AGENDA OF THE LANDMARKS COMMISSION

MONDAY, OCTOBER 7, 2019, 4:30 PM
CITY HALL, ROOM 310

Report to the
Landmarks Commission
of the City of Green Bay

AGENDA ITEM # D.1.

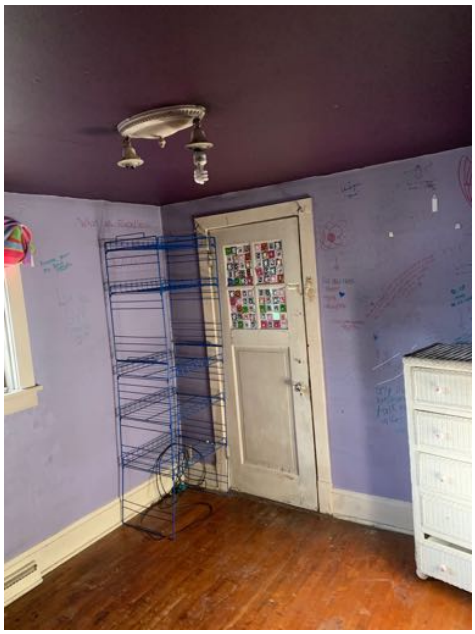
Replace balcony door

- **Remove storm door**
- **existing door doesn't seal**
- **paint is peeling**
- **door is water damaged**
- **Yes those are condoms glued to the door**

9 – Replace rear balcony door. LC staff recommends approval given that the current door is not visible from a public right-of-way and is hidden by a storm door.
